Accessibility Report

New Primary School in Murrumbateman 2 Fairley Street, Murrumbateman, NSW

Report No: MURR-DD-SSDA-RPT-0001
Revision: A
Date: 14 May 2021

NEW PRIMARY SCHOOL IN MURRUMBATEMAN
2 FAIRLEY ST MURRUMBATEMAN NSW 2582
DRAWING NAME
SITE PLAN

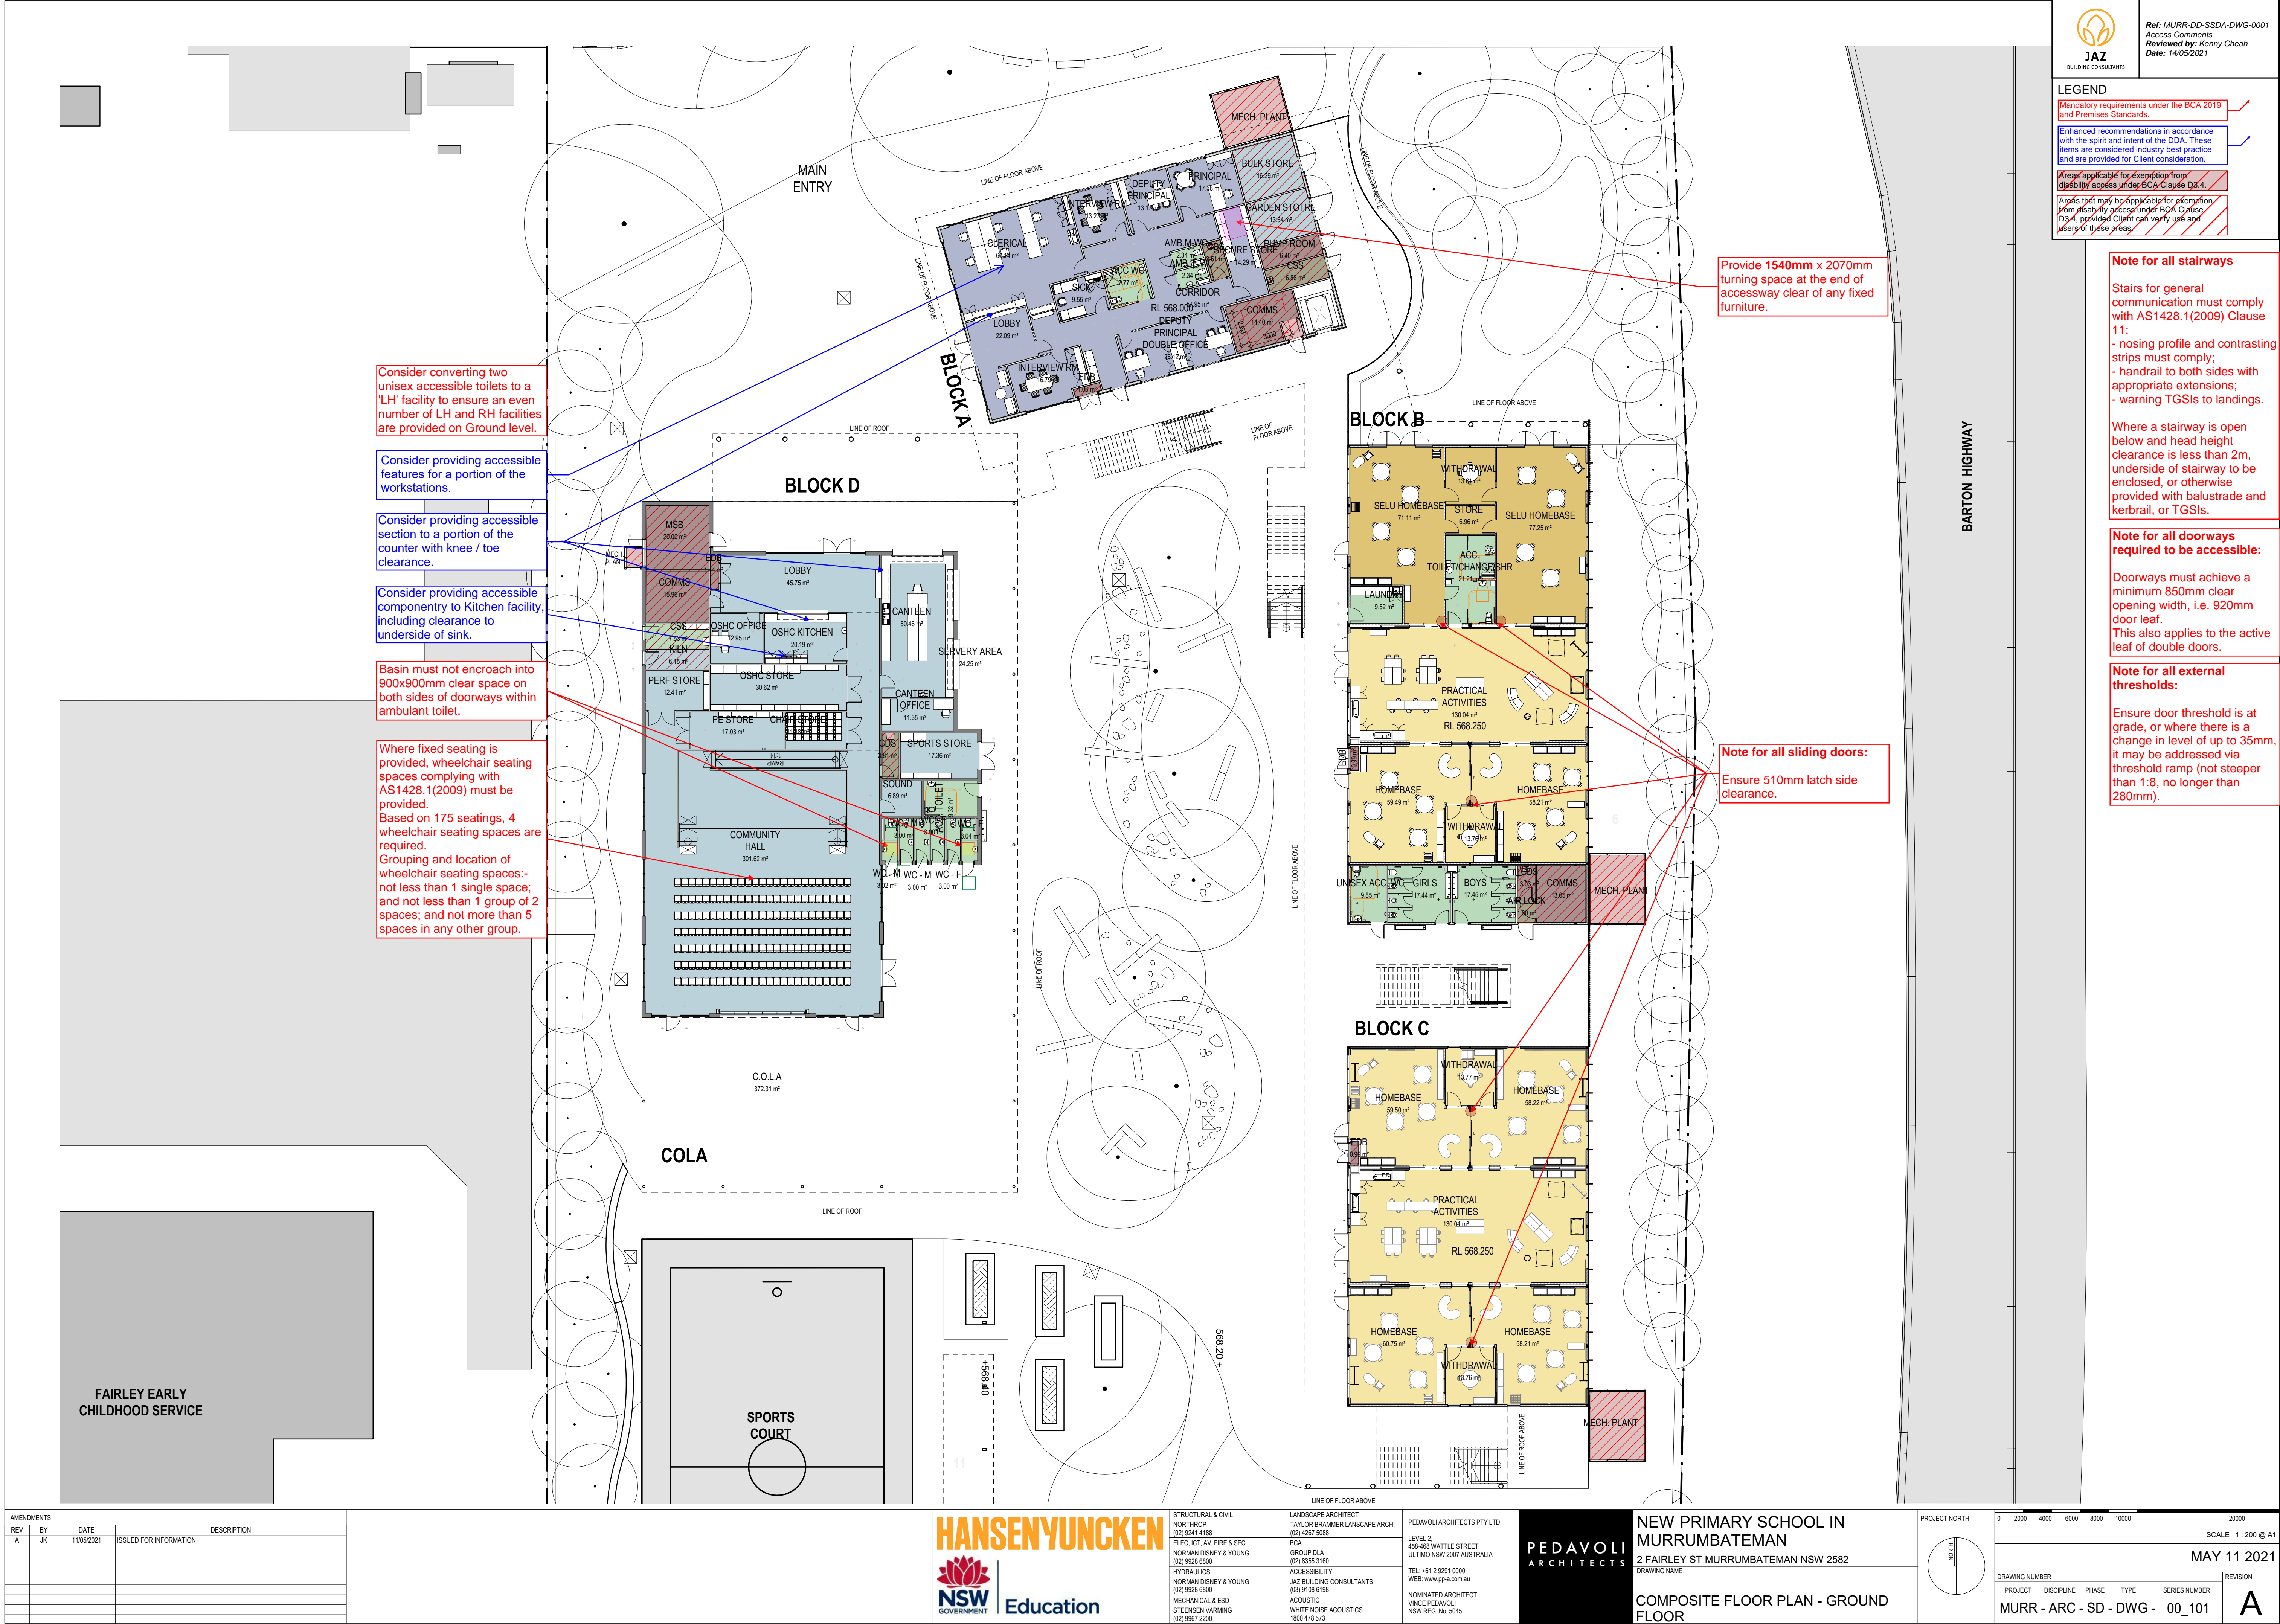
Areas that may be applicable for exemption from disability access under BCA Clause D3.4, provided Client can verify use and users of these areas.

BLOCK A - GROUND FLOOR - FURNITURE PLAN

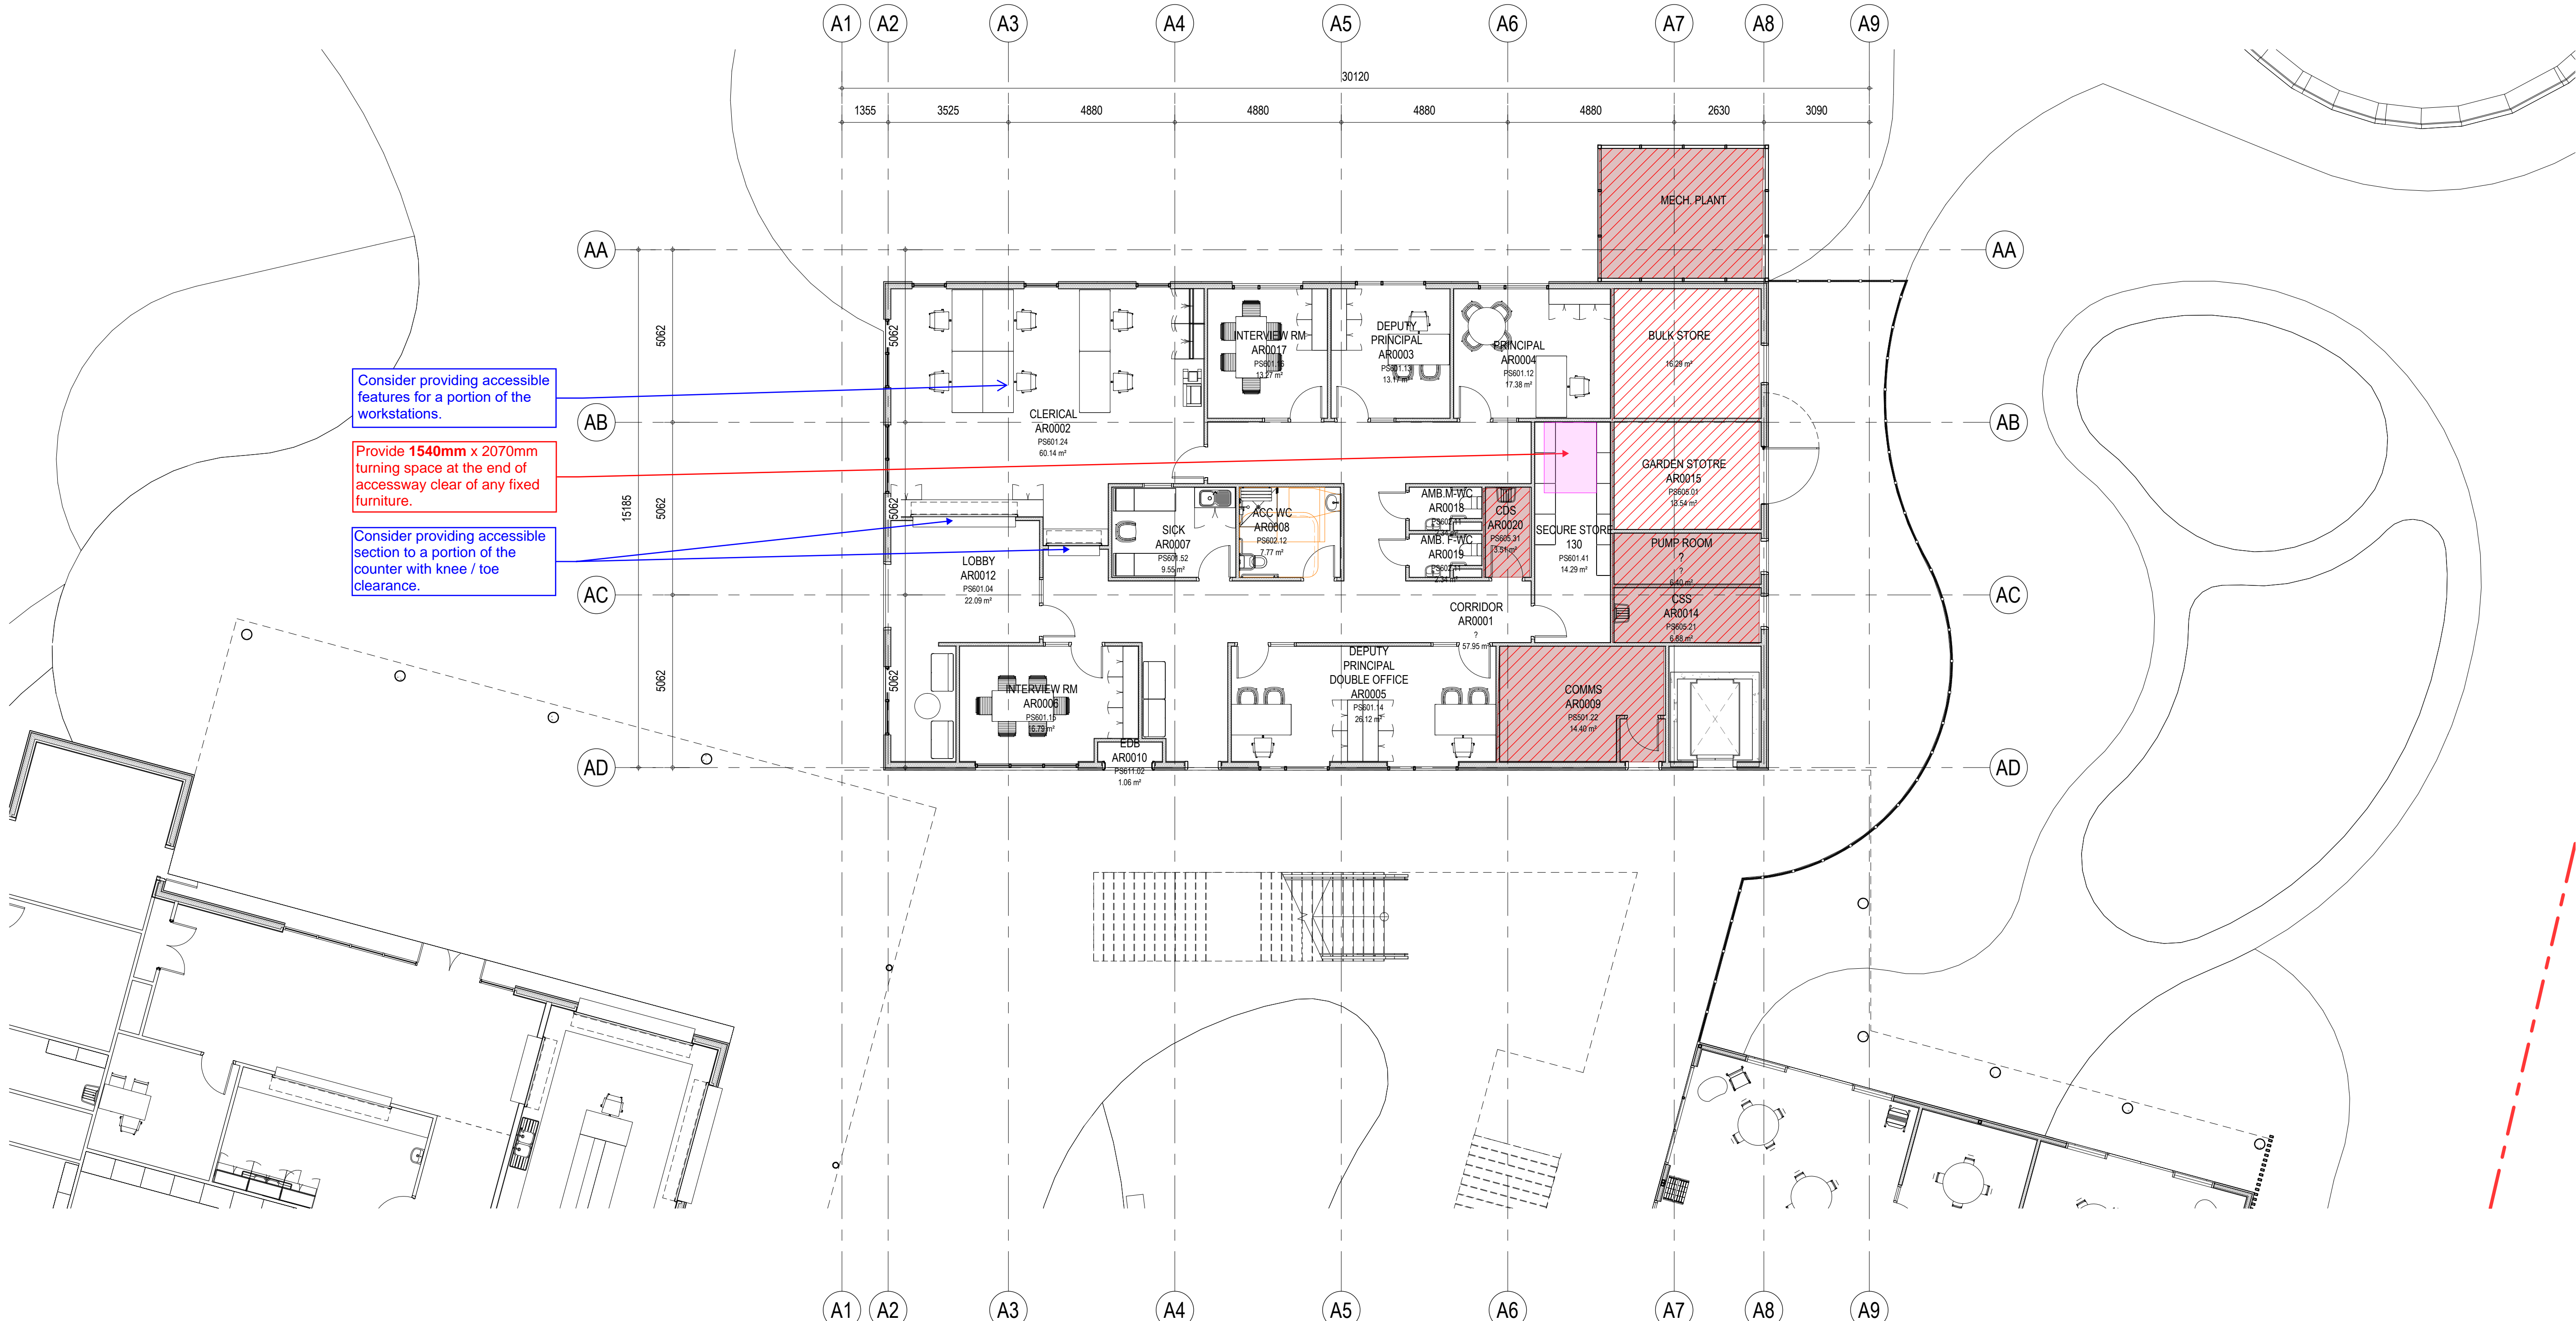
Areas that may be applicable for exemption from disability access under BCA Clause D3.4, provided Client can verify use and users of these areas.

BLOCK A - FIRST FLOOR - FURNITURE PLAN

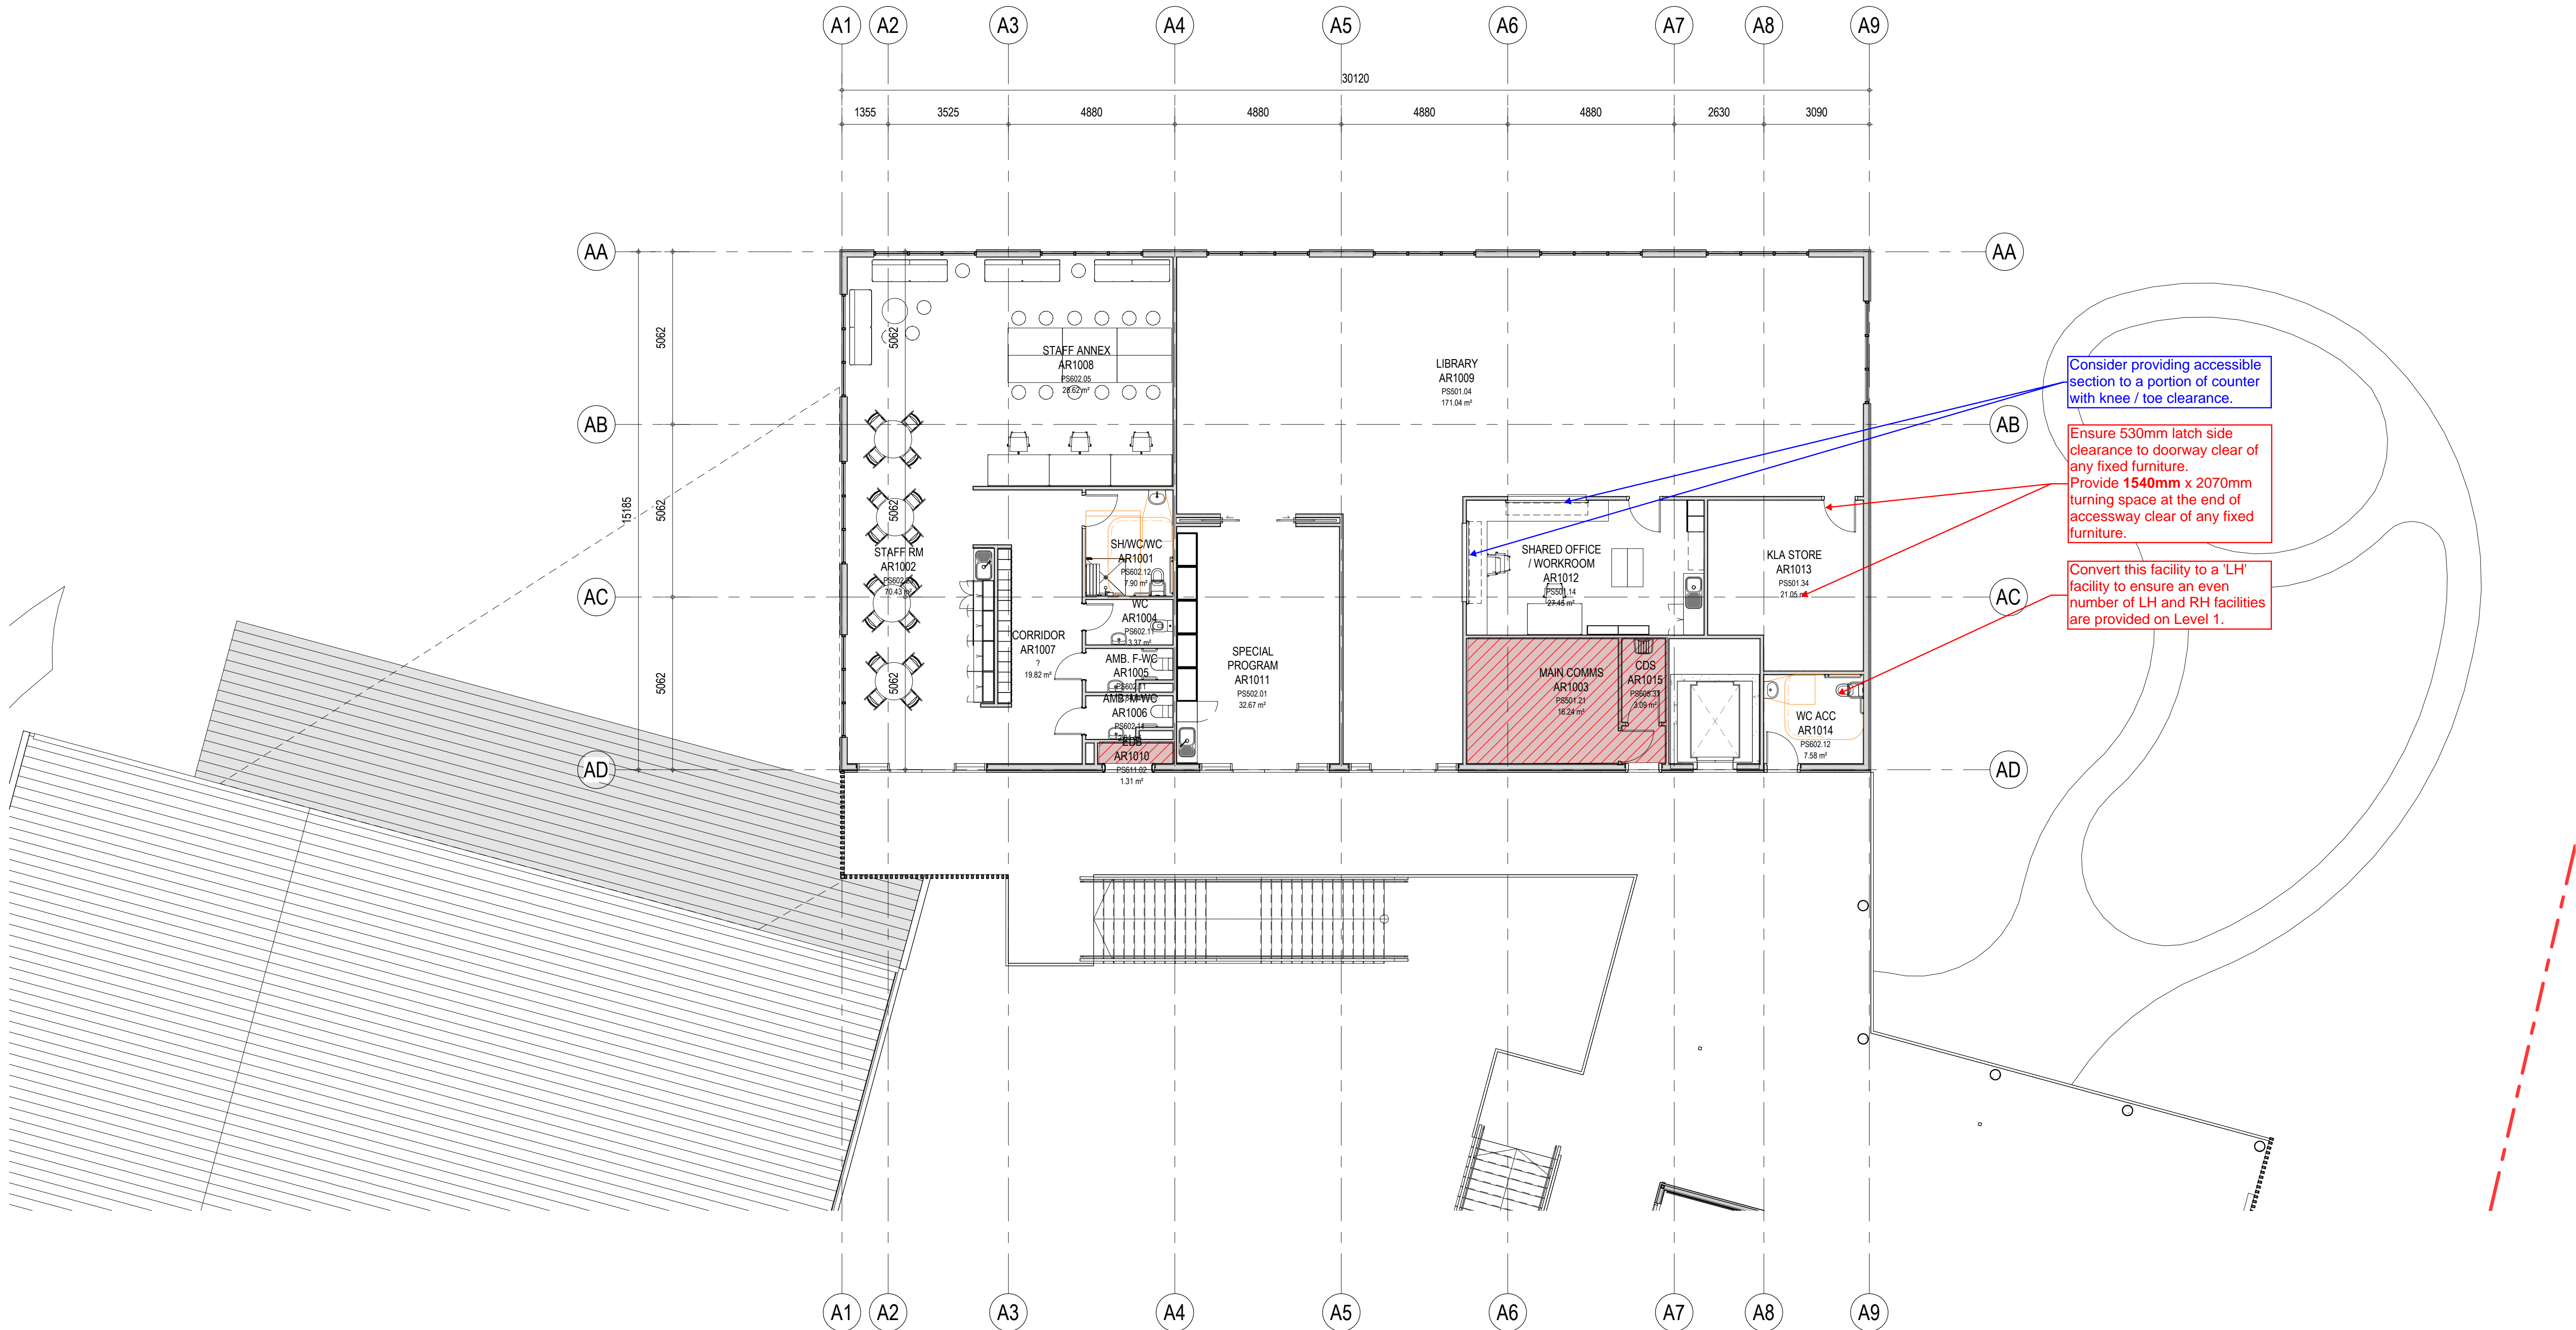
Areas that may be applicable for exemption from disability access under BCA Clause D3.4, provided Client can verify use and users of these areas.
